Albury to Illabo Preferred Infrastructure Report

**INLAND
RAIL**

This Preferred Infrastructure Report has been prepared for the Albury to Illabo (A2I) section of the Inland Rail program (the proposal). The Preferred Infrastructure Report addresses the direction made by the Planning Secretary in accordance with section 5.17(6)(b) of the *Environmental Planning and Assessment Act 1979* (EP&A Act) and describes and assesses the proposed amendments.

Figure 3-6 Key features of Albury Station and surrounds

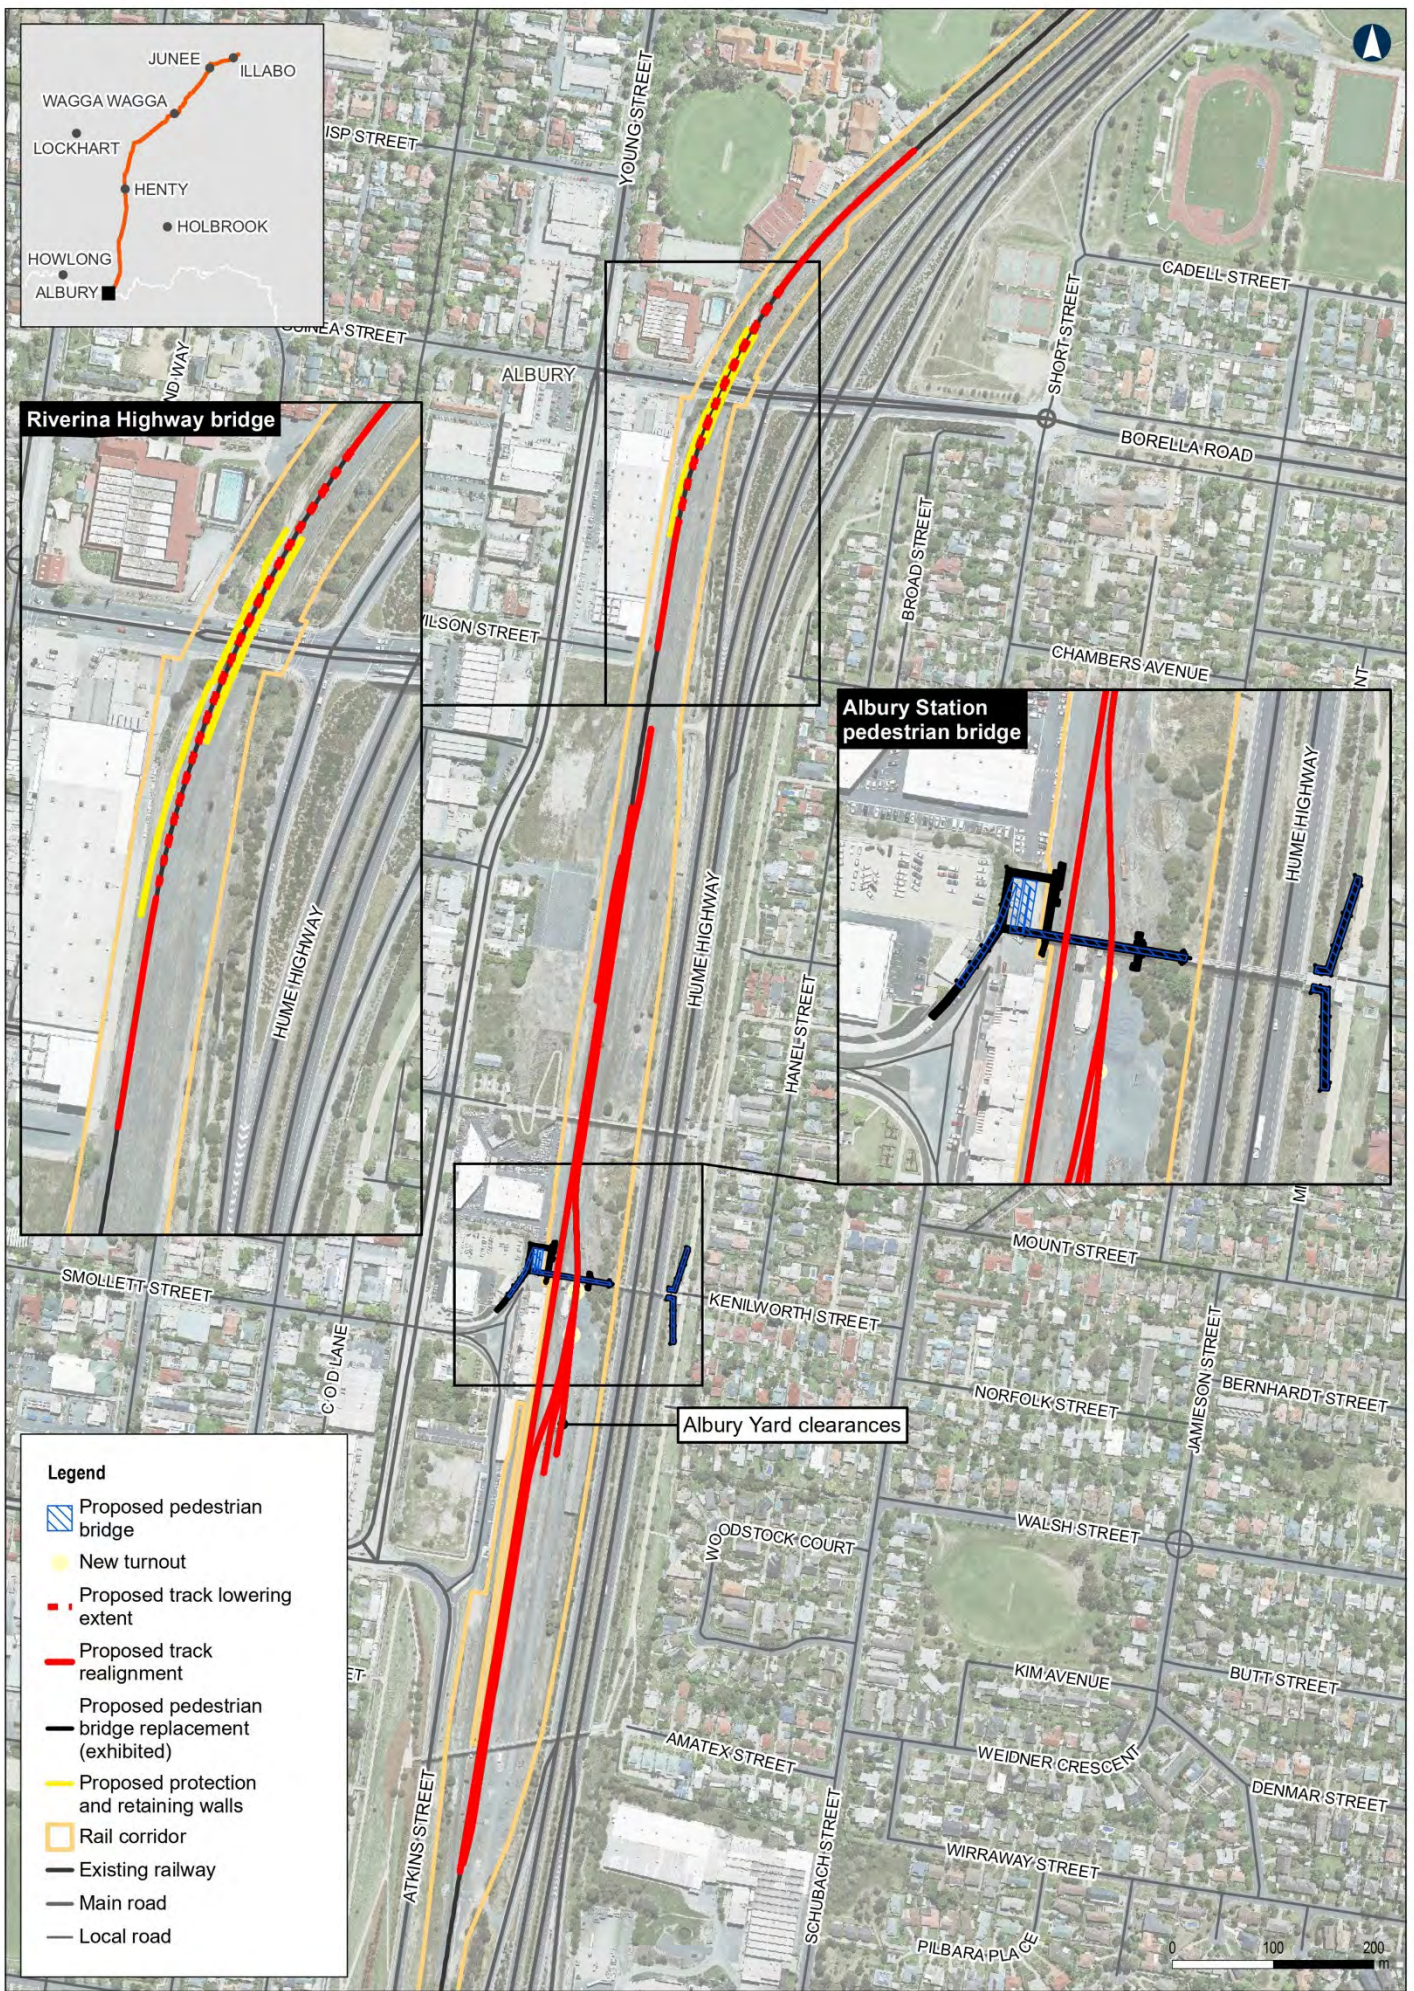
Figure 7-8 in chapter 7 of the EIS incorrectly included a collision protection wall along the eastern boundary of the rail corridor near The Scots School in addition to those proposed at the Riverina Highway bridge where the track would be lowered. The design does not require a collision protection wall at the eastern boundary of the rail corridor and a wall is not proposed. Figure 3-6 provides an update of the design at the Riverina Highway bridge.

Figure 3-9 Key features of Junee to Illabo clearances

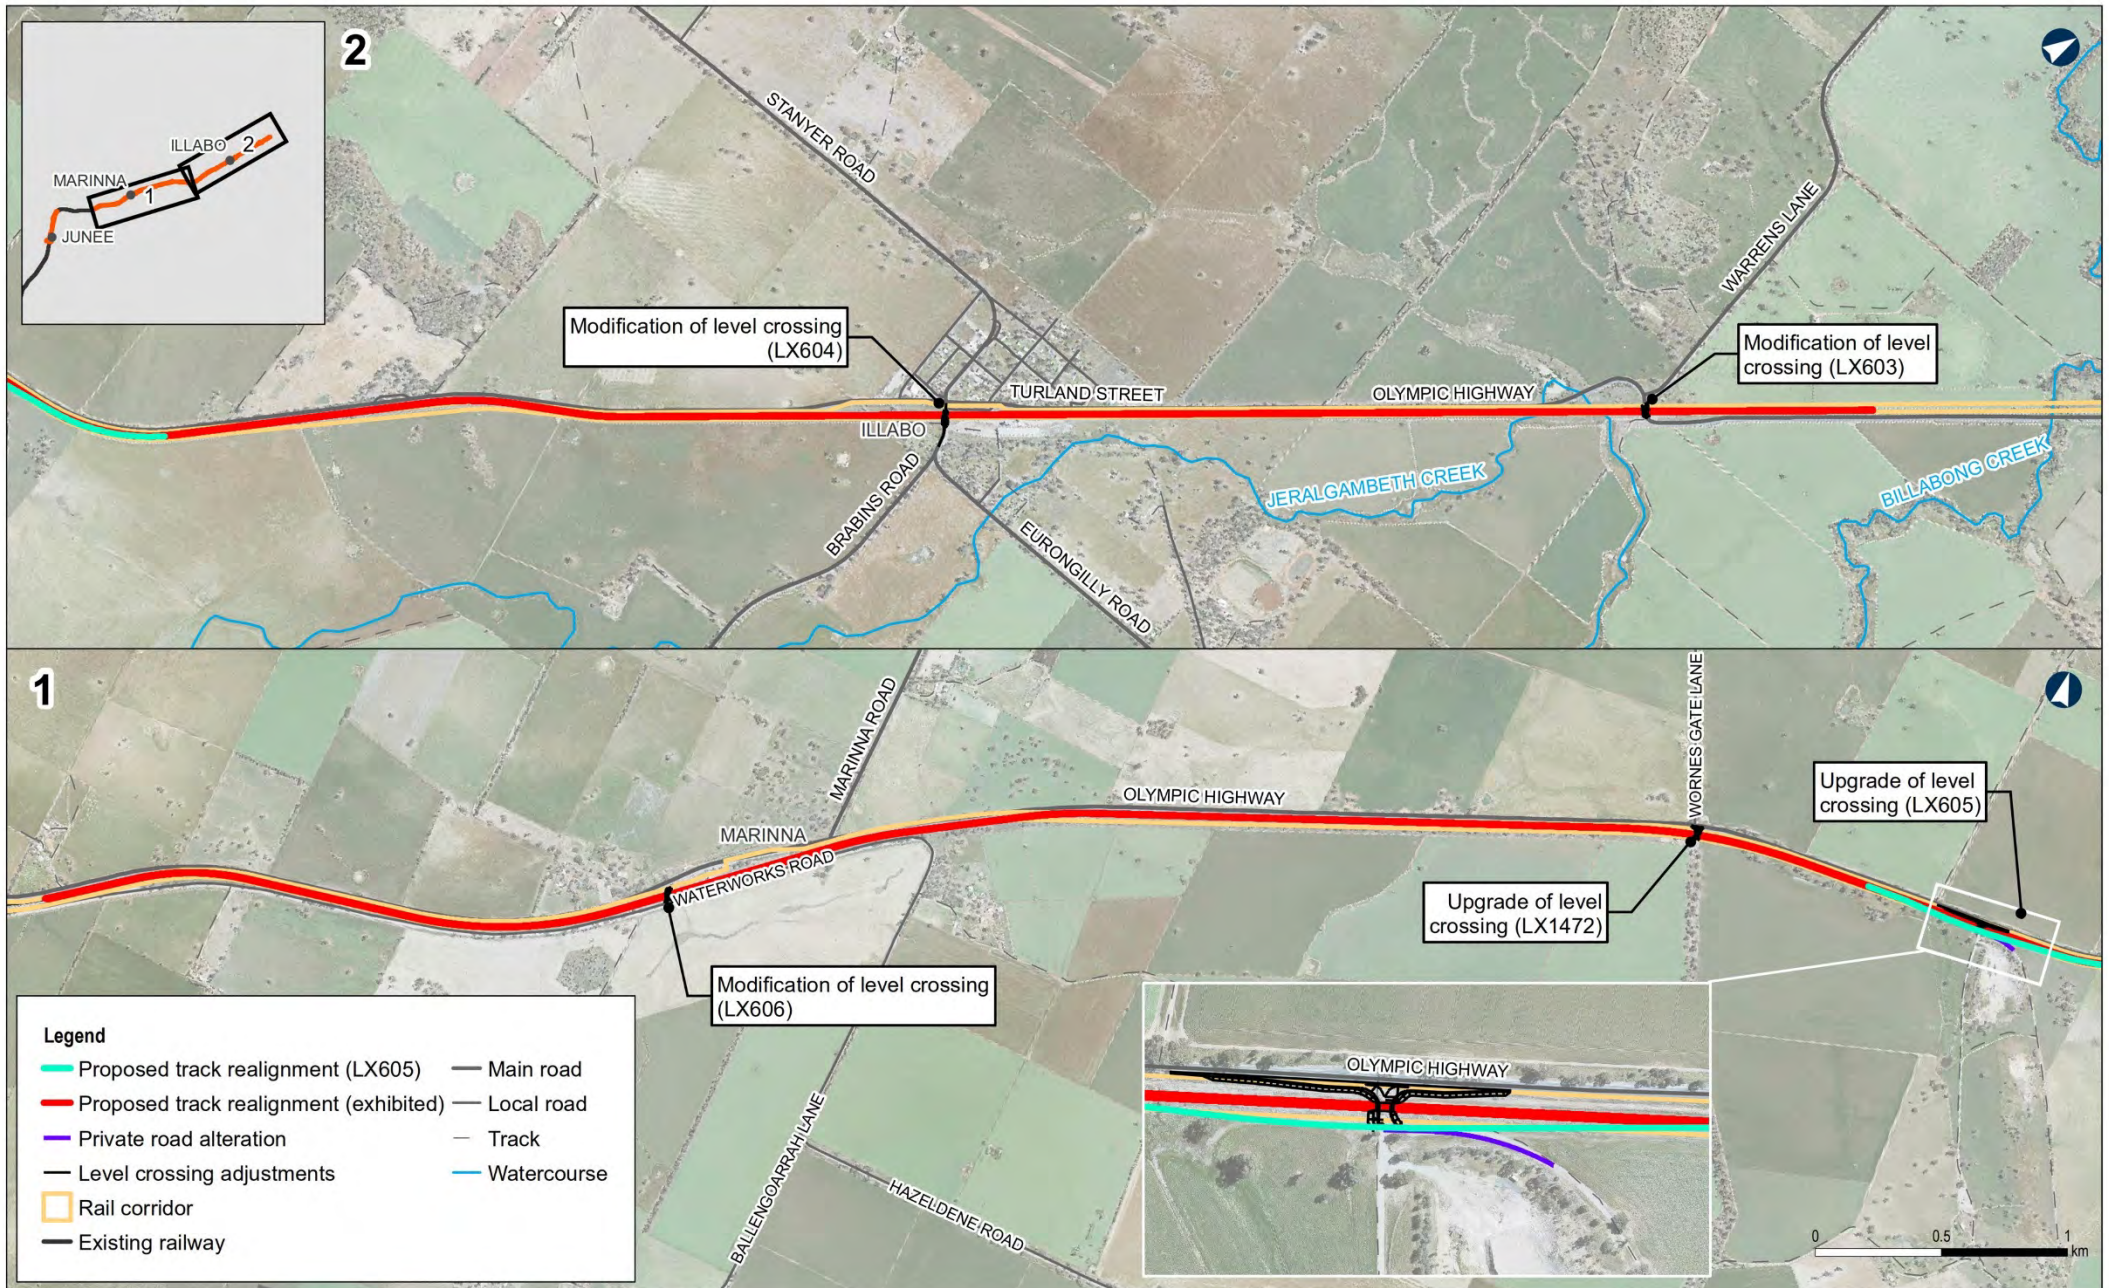
3.2.1.4 Change to level crossing LX605 at the Junee to Illabo clearances enhancement site

To accommodate the realigned track, the rail corridor boundary would be adjusted and approximately 0.5 hectares (ha) of the Crown road adjacent to the rail corridor would need to be acquired. Subject to detailed design and property agreements, it is not anticipated that the land requirement of the Crown road would sever the road or limit the ongoing use of the Crown land.

The level crossing would still be upgraded from a passive to an active level crossing as previously proposed in the exhibited EIS.

Figure 3-10 Revised Construction layout of enhancement site

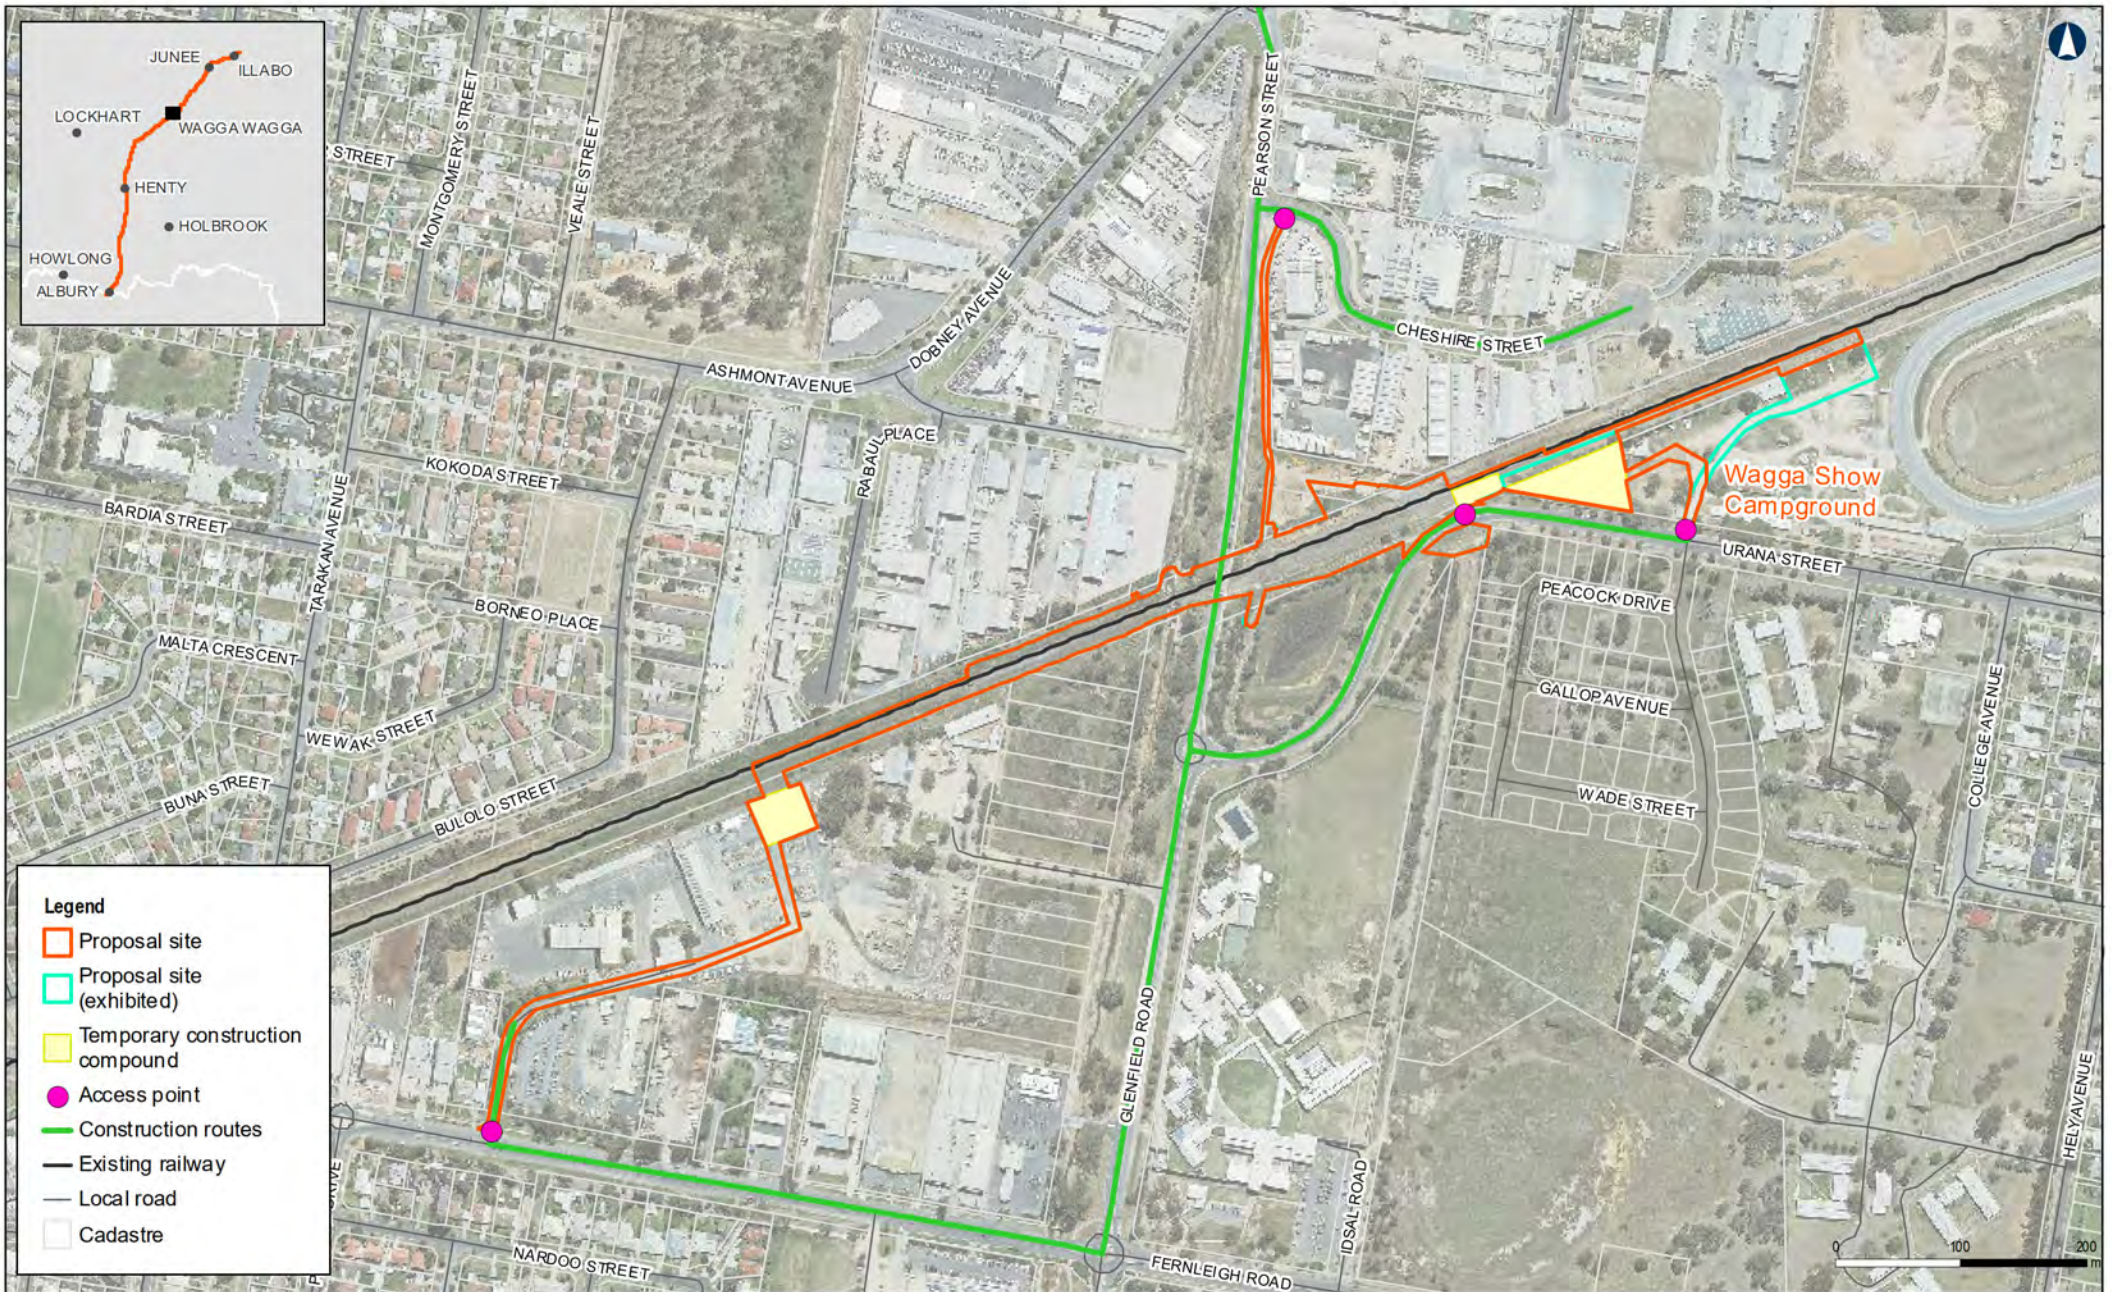
Precinct	Enhancement site	Description of change to the proposal site
Wagga Wagga	Pearson Street bridge (refer to Figure 3-10)	Part of the Wagga Show Campground was identified for use as a temporary construction compound. Wagga Wagga Showground Society has subsequently identified the need to use this area during construction. In response, in consultation with the Wagga Wagga Showground Society, the proposal site has been refined to relocate the temporary construction compound to the south-west of the property, between the existing rail corridor and Urana Street. Site access would remain at the existing entry point at Urana Street.
	Cassidy Parade pedestrian bridge (refer to Figure 3-11)	To accommodate the changes in pedestrian bridge design (refer to section 3.2.1.1) the proposal site has been extended further west within the rail corridor and the Cassidy Parade road reserve. To improve access for construction of the ramp off Brookong Avenue, an additional construction area has also been identified in the Telstra depot property on Brookong Avenue. No change to site access points is proposed.
